TECHNICAL EVALUATION REPORT

REVIEW OF LICENSEES' RESOLUTION OF OUTSTANDING ISSUES FROM NRC EQUIPMENT ENVIRONMENTAL QUALIFICATION SAFETY EVALUATION REPORTS (F-11 and B-60)

INDIANA AND MICHIGAN ELECTRIC COMPANY
DONALD C. COOK NUCLEAR PLANT UNIT 2

NRC DOCKET NO. 50-316

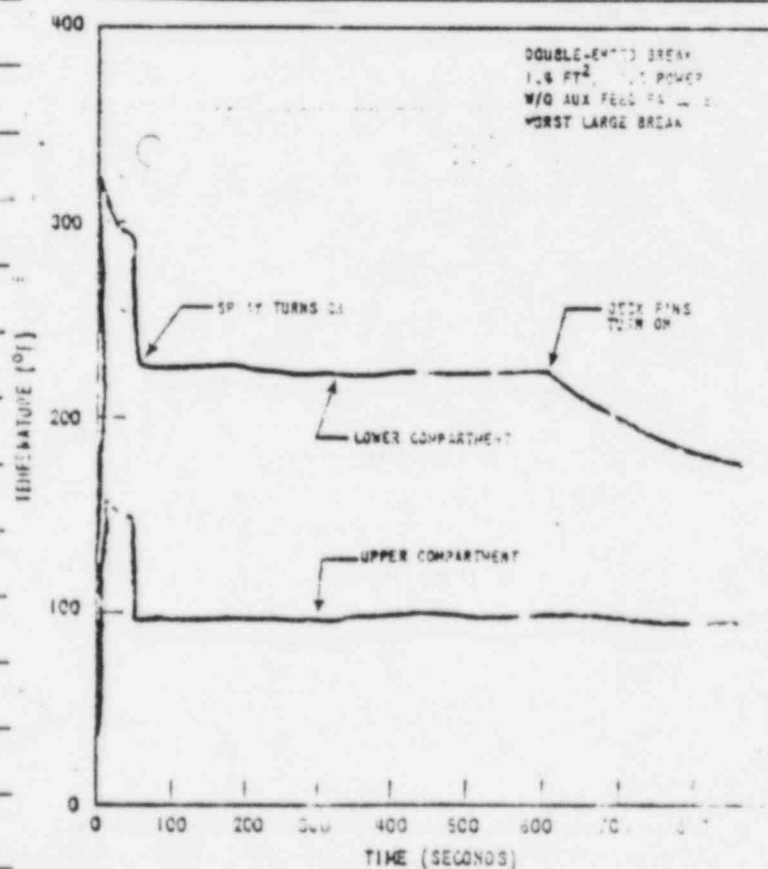
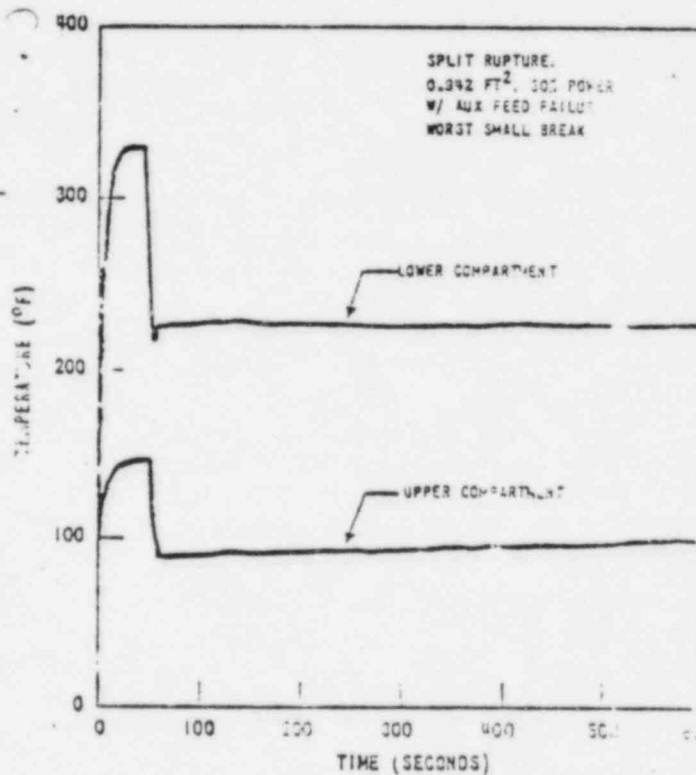
The test profile envelopes the MSLB curves on p 5g but not the LOCT profile shown on page 5h. The license SCEW sheet state that the required time is 1 hour. However as indicated on page 5j, 3 of 4 samples of Continental Wire did not pass the test. The DOR Guidelines state

If a component fails at any time during the test, even in a so called "fail safe" mode, the test should be considered inconclusive with regard to demonstrating the ability of the component to function for the entire period prior to the failure.
